DEVIATION REQUEST AND DECISION FORM

Project Name :	Meadowlake Industrial Park Filing No. 1 Preliminary Plan
Schedule No.(s) :	4300000552
Legal Description :	A PORT OF THE E2 OF SEC 09-13-64 DESC AS FOLS: BEG AT THE NE COR OF SD SEC 9; TH S 00<43'37" W ALG THE E LN OF SD SEC 9 1491.36 FT FOR POB; TH CONTINUE CONT S 00<43'37" W ALG SD E LN 1808.88 FT, N 89<45'08" W 2406.04 FT, N 19<30'09" W 675.81 FT TO A PT ON THE W LN OF SD E2, N 00<48'03" E ALG SD W LN 1176.51 FT, TH S 89<40'19" E PARA WITH THE LN OF SD E2 2638.19 FT TO POB

Deviation Exhibit

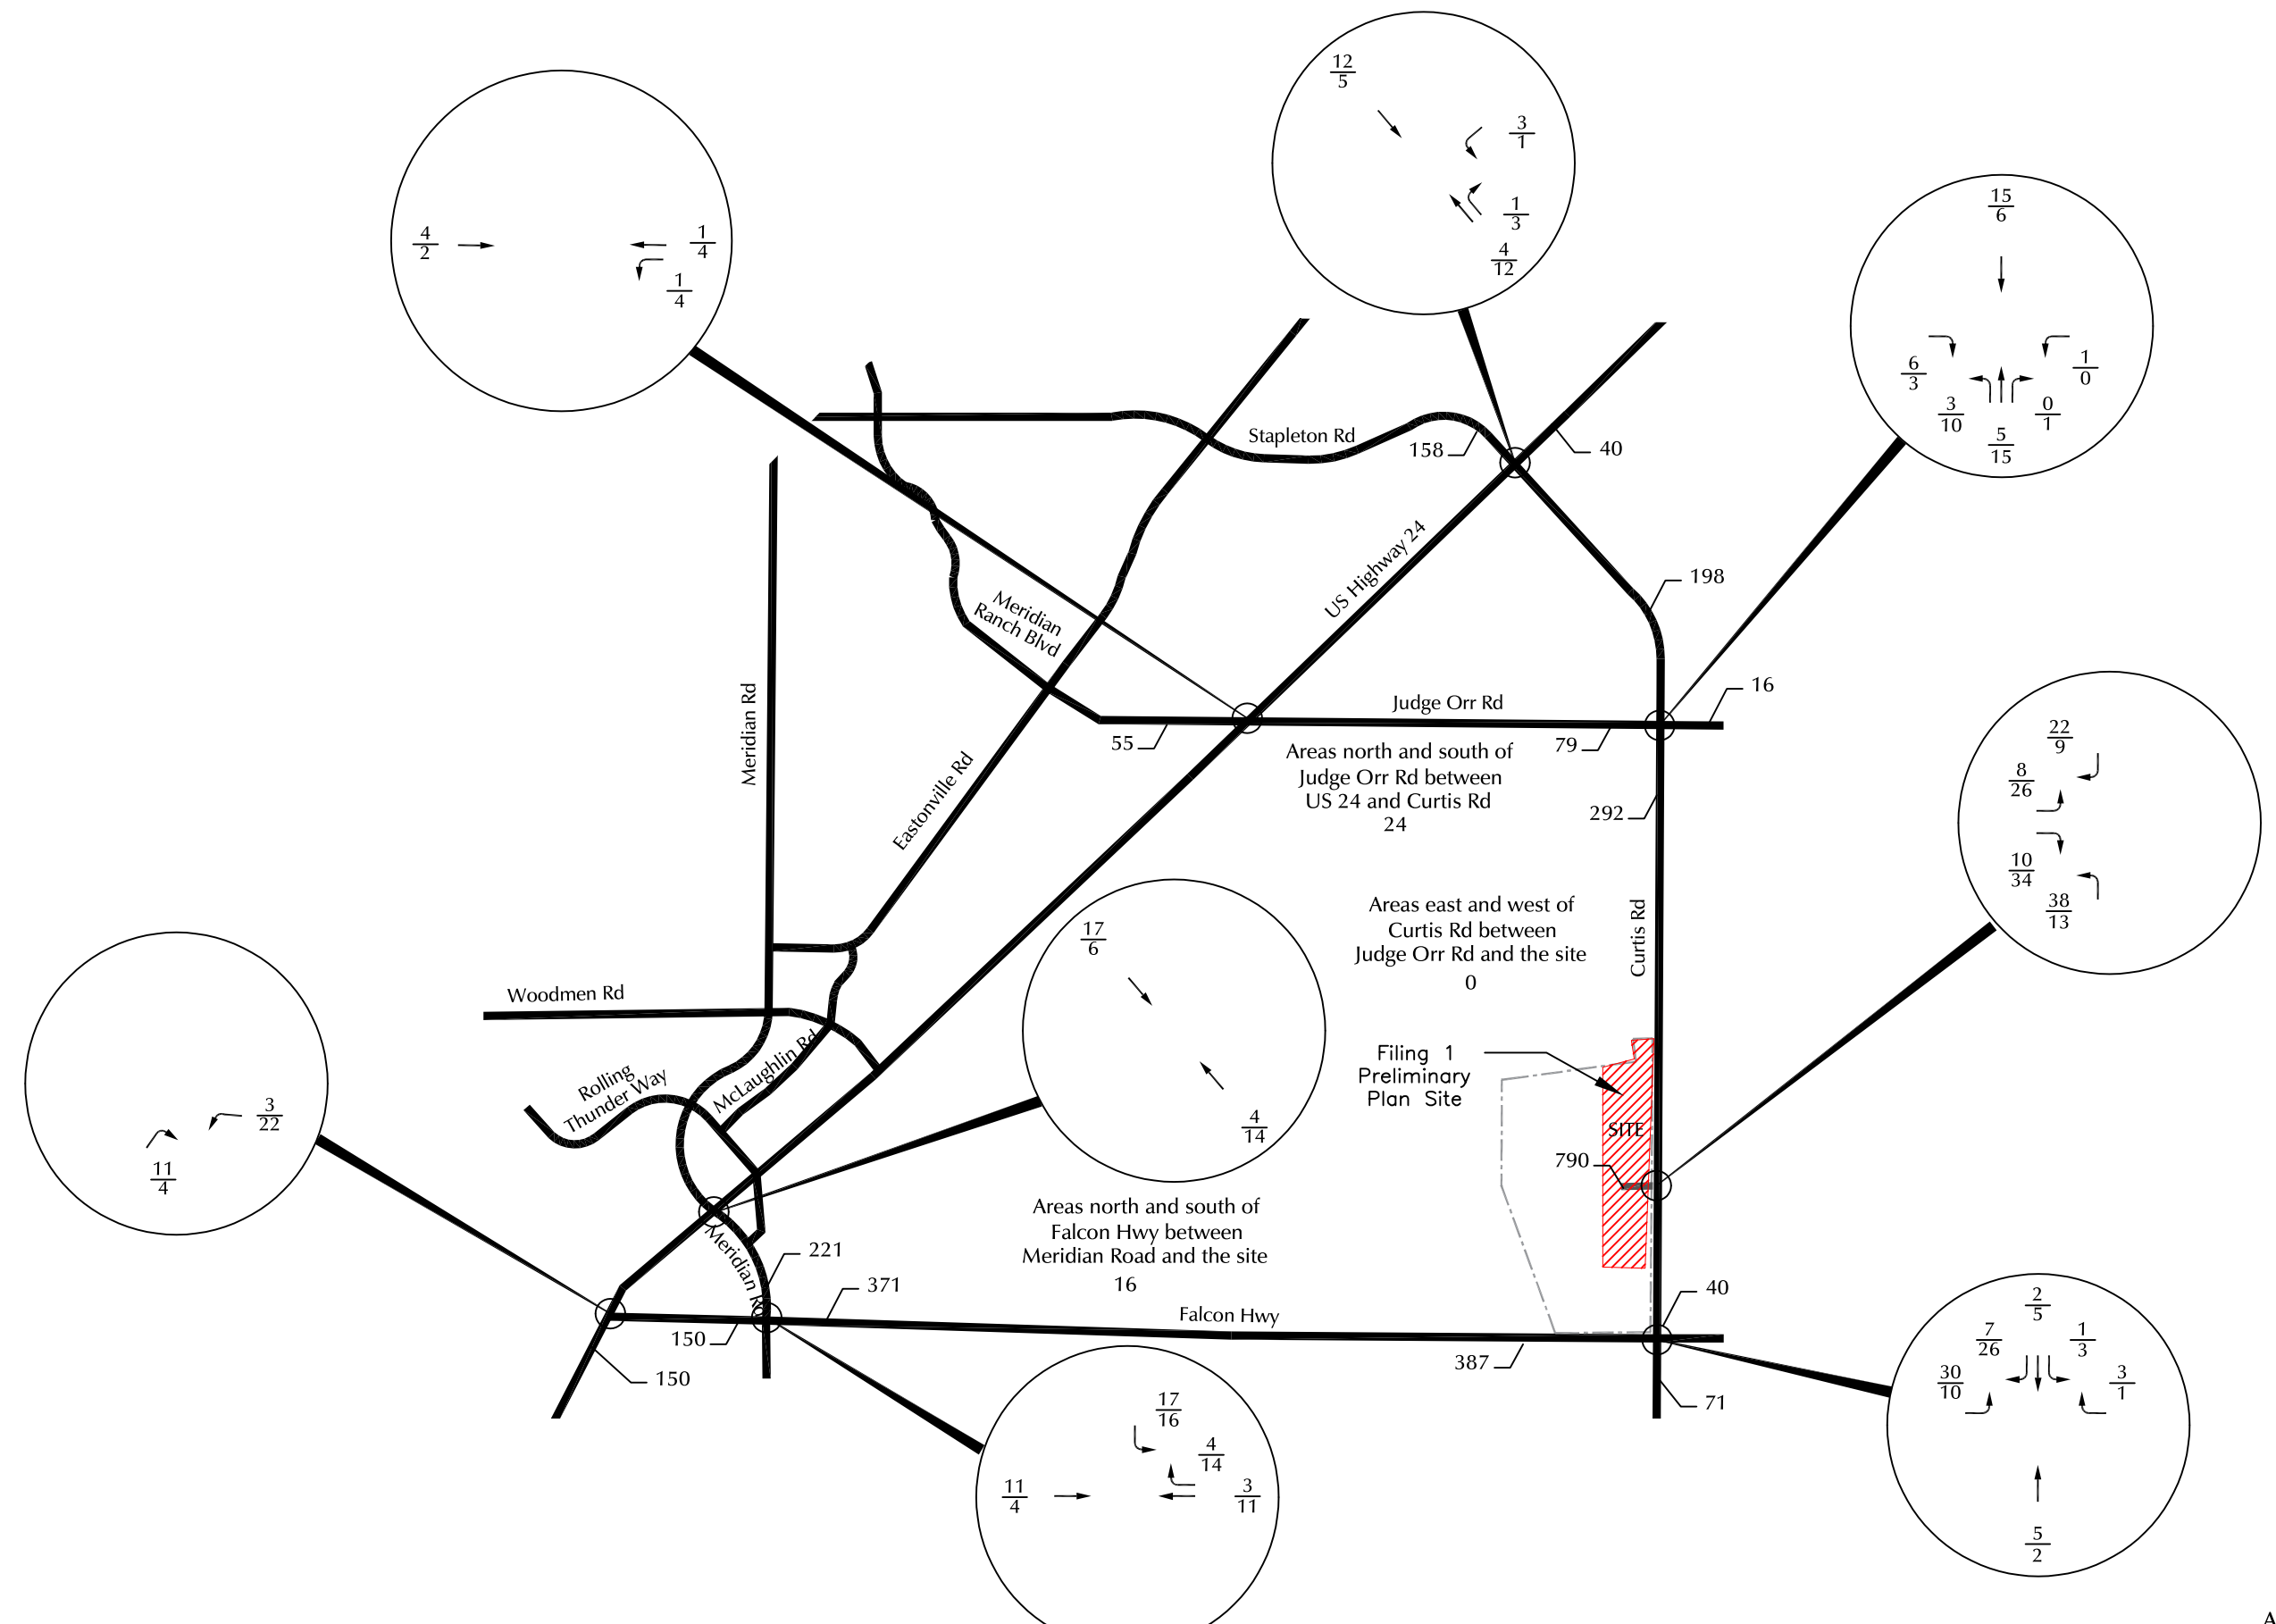
is there any CDOT criteria that may help your justification for keeping the lane as is in the interim?

Please provide further justification as this is not sufficient for approval of this deviation. Identify whether the existing lane can function safely and adequately as is. Recommend that you indicate that this is in line with the condition of approval indicated by staff with Saddlehorn filing 4.
